DART AEROSPACE LTD	Work Order:	116482
Description: Crosstube Assembly	Part Number:	D407-667-145
Inspection Dwg: D407-667-145 Rev: C		Page 1 of 2

DESIGN	RF	DART AEROSPACE LTD	
DRAWN	RF	HAWKESBURY, ONTARIO, CANADA	
CHECKED	RF	DRAWING NO.	REV. C
MFG. APPR.	RF	D407-667-145	SHEET 3 OF 4
APPROVED	RF	TITLE	SCALE
DE APPR.	RF	CROSTUBE ASSY (407 HIGH FWD)	NTS
DATE	08.11.06	COPYRIGHT © 2002 BY DART AEROSPACE LTD	
THIS DOCUMENT IS PRIVATE AND CONFIDENTIAL AND IS SUPPLIED ON THE EXPRESS CONDITION THAT IT IS NOT TO BE USED FOR ANY PURPOSE OR COPIED OR COMMUNICATED TO ANY OTHER PERSON WITHOUT WRITTEN PERMISSION FROM DART AEROSPACE LTD.

DRAWING NO. D407-667-145	TITLE CROSSTUBE ASS'Y (407 HIGH FWD)	REV. C	DART AEROSPACE LTD ENGINEERING ORDER		D.E.O. NO. D407-667-145-C-1	SHEET NO. SHEET 1 OF 1	SCALE NTS
DRAWN 47	CHECKED ASS	MFG. APPR. AB	APPROVED WD		DE APPR. H		
DATE 11.07.15	DATE 11.07.22	DATE 11.07.22	DATE 11/07/22		DATE 11.07.21

DRAWING NO. D407-667-145	TITLE CROSSTUBE ASS'Y (407 HIGH FWD)	REV. C	DART AEROSPACE LTD ENGINEERING ORDER	D.E.O. NO. D407-667-145-C-2	SHEET NO. SHEET 1 OF 1	SCALE NTS
DRAWN AJS	CHECKED	MFG. APPR.	APPROVED	DE APPR.		
DATE 12.08.02	DATE 12.08.02	DATE 12.08.02	DATE 12.08

DETAIL P
BONDING STRAP INSTALLATION 2 PL

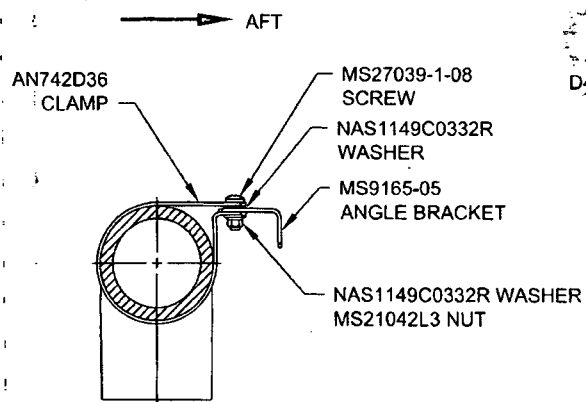
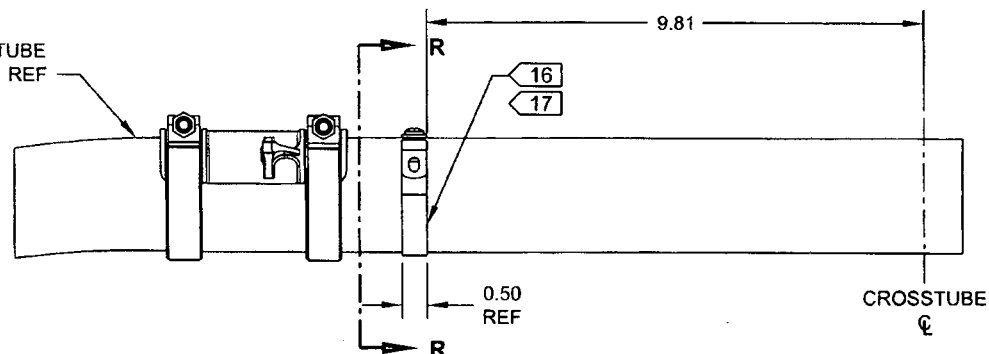
ADD ELECTRICAL GROUNDING STRAP

ITEM	QTY -145	PART NUMBER	DESCRIPTION
1	X	D407-667-145	CROSSTUBE ASSEMBLY (407 HIGH FWD)
10	2	AN742D36	CLAMP
11	2	MS9165-05	ANGLE BRACKET
12	2	MS21042L3	NUT (OR MS21042-3)
13	2	MS27039-1-08	SCREW
14	4	NAS1149C0332R	WASHER (OR AN960C10L)

- 16) MASK AREA UNDER CLAMP PRIOR TO PAINTING
- 17) SEAL EDGES WHERE AN742D36 CLAMP MEETS WITH THE CROSSTUBE USING SIKAFLEX-241/-291 OR MIL-S-8802 CLASS B2 OR PROSEAL 890 SEALANT
- 18) PERFORM RESISTANCE CHECK TO ENSURE MAX RESISTANCE IS 10 MILLIOHMS
